**Consumers
Power
Company**

RELATED CORRESPONDENCE

Attached are copies of audit reports and of certain other documents recently issued by the MPQAD.

AUDIT REPORTS

PAGE 3 OF 6

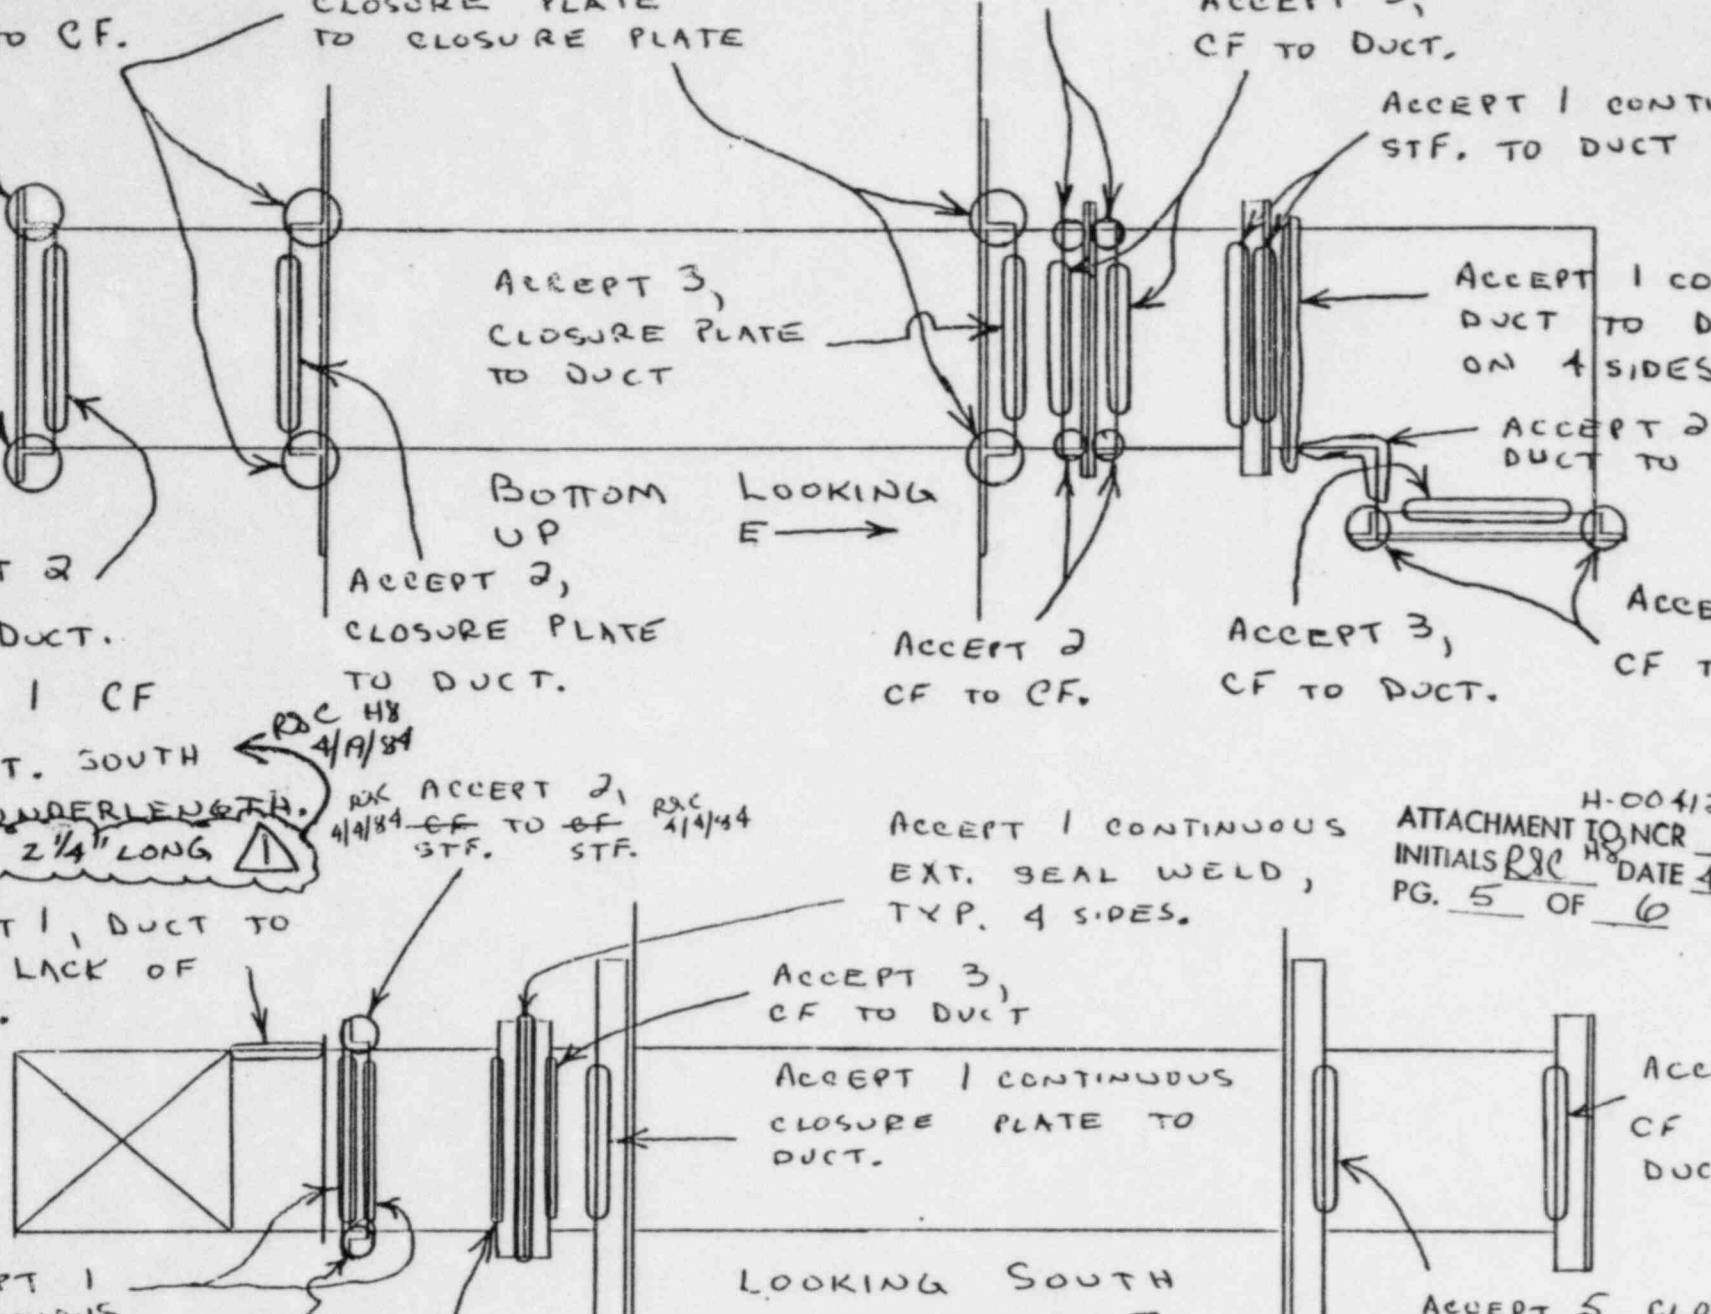
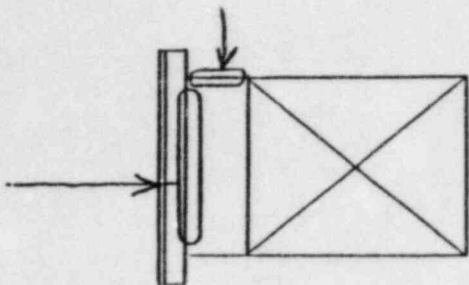
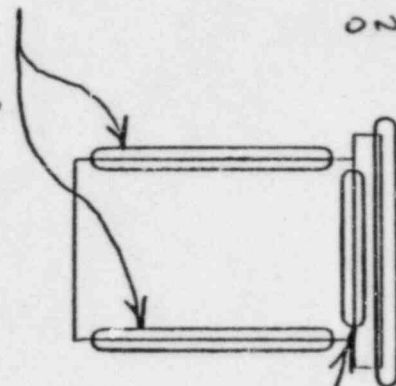
12 REQUIREMENT
① BECHTEL TECH. SPEC. 7220-M-151A Q, REV. 18, PARAGRAPH 14.8.4.d STATES IN PART, "THE WELD SIZE SHALL MEET OR EXCEED THE SPECIFIED SIZE REQUIREMENTS." ... DRAWING C844 Q REV. 20, SECTION M REQUIRES STARTER WELDS TO BE 2 1/2" LONG FOR DUCTS WHICH ARE 12" X 10".
(SEE PAGE 3 OF 6.)

ACCEPT 1
CF TO DUCT.
REJECT 2
CF TO DUCT,
TOP AND
BOTTOM,
BOTTOM,
UNDERLENGTH.

TOP WELD IS 1 5/8" LONG,
BOTTOM WELD IS
1 7/8" LONG.
